Re: G170310/A001
Trade/Device Name: NTK Optimal Keratoplasty (Opti-K) System
Dated: April 11, 2018
Received: April 16, 2018
CMS Category: A
Annual Report Due: One Year from the Date of This Letter

Additional Recommendations and Considerations

Figure 1. Mechanical drawing of SAWSR.

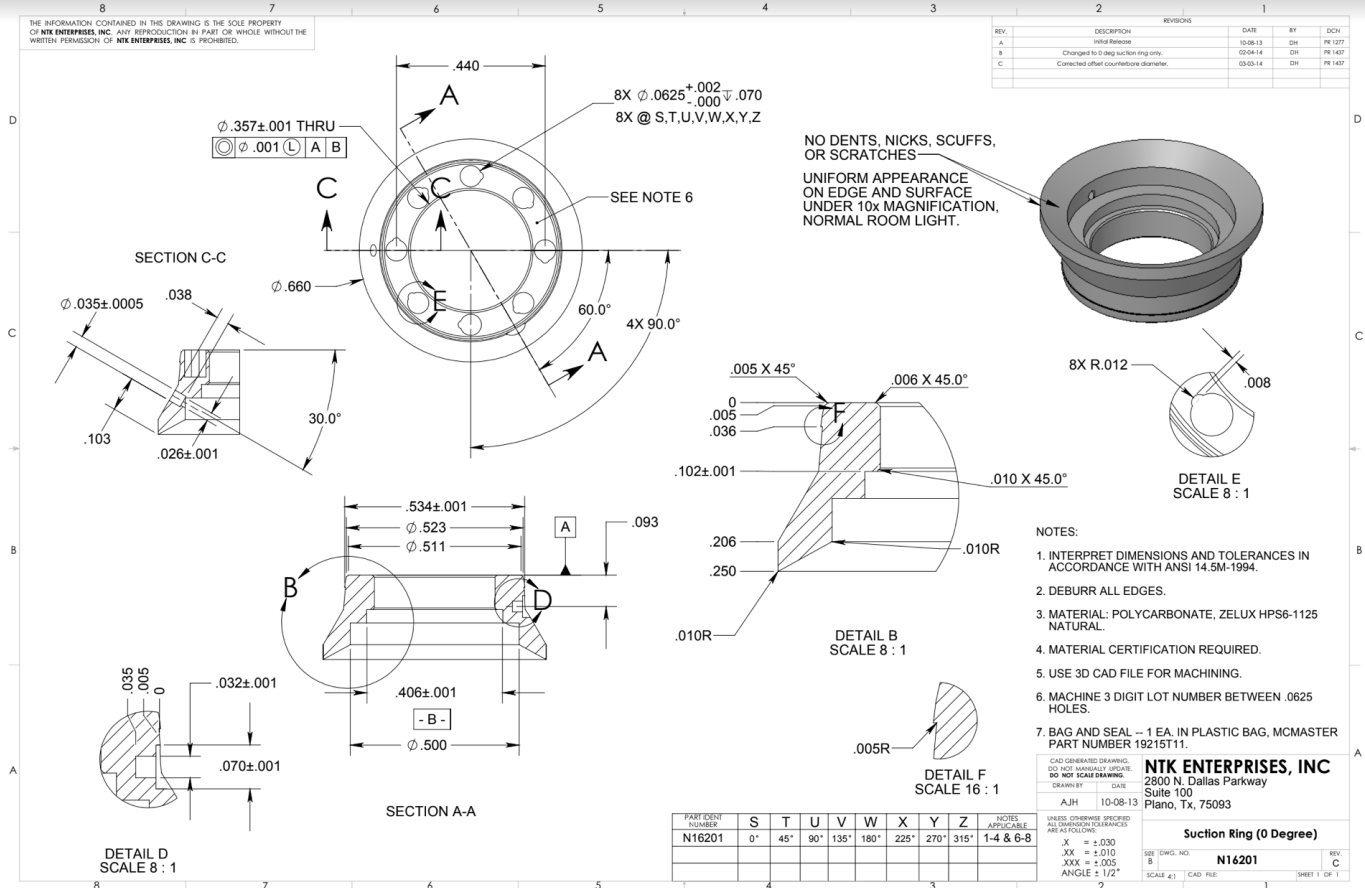
- 3. Regarding your response to deficiency 17, you further explain and confirm that SAWSR suction produces an average increase of only 8.6 ± 0.7 mmHg in pig eyes. However, we do not believe there would only be a small intraocular pressure (IOP) elevation if the SAWSR does applanate the cornea to a diameter of over 11 mm. We are concerned that there may be artifactual considerations (e.g., scleral measurements with a tonopen are not comparable to corneal measurements, or a leak in the eye allows fluid to be expressed out during applanation) that may have contributed to the results of your pig study. Alternatively, it is possible that your description of the SAWSR design is not sufficient such that we can understand why the IOP rise would be as small as 8.6 mmHg (e.g., the SAWSR window is a bowl-shaped surface that approximately matches the corneal curvature). Therefore, please provide additional details to explain the small IOP elevation, either by giving a more detailed and accurate description of the SAWSR system or by identifying and explaining the*

reason(s) that may have contributed to inaccurate measurements. If the former, you should provide complete details to describe the SAWSR design and explain how you calculate the increase in IOP. If the latter, we recommend that you provide a discussion of your study design and/or updated results from testing based on addressing any possible confounding issues resulting from your set up.

Response. The Optimal Keratoplasty SAWSR has a 9.1 mm diameter sapphire window (Figure 1) that contacts the cornea under light manual pressure during the few seconds required for alignment/centering followed by application of a negative pressure to the suction ring to stabilize the SAWSR in place. (For comparison, the Intralase FS patient interface device window is 12-13 mm in diameter, sufficient to clearly show the limbus.) After centration of the SAWSR, suction is applied for 15.5 ± 1.8 seconds (N = 24; range 13-19; measured from randomly selected video recordings). During this period, the 2.5 second treatment is delivered, followed by a 2-3 second brief recorded inspection of the resulting pattern. As noted, our early data with enucleated and cannulated pig eyes recorded an average increase in intraocular pressure of only 8.6 ± 0.7 mmHg, a value which has been challenged. A similar experimental arrangement with enucleated pig eyes has been published by Vetter and colleagues¹ who compared IOP rises with 4 approved femtosecond lasers used for the creation of LASIK flaps in humans. When suction was turned on with the VisuMax laser, an increase in IOP of only 5 ± 2 (N = 12; range: 3 to 11) mmHg was recorded (Table 2; Vetter, et al.). The range of pressure increases reported for the 3 other lasers during suction application was 7 to 147 mmHg. Hence, the data reported in the early investigation with the Optimal Keratoplasty device, while low, is within the range found for 4 commercially available applanating femtosecond lasers using the same experimental ex vivo animal model. Owing to the potential for underestimating IOP rise in this model, we take 8.6 mmHg as the low end of the probable pressure rise during suction with the SAWSR.
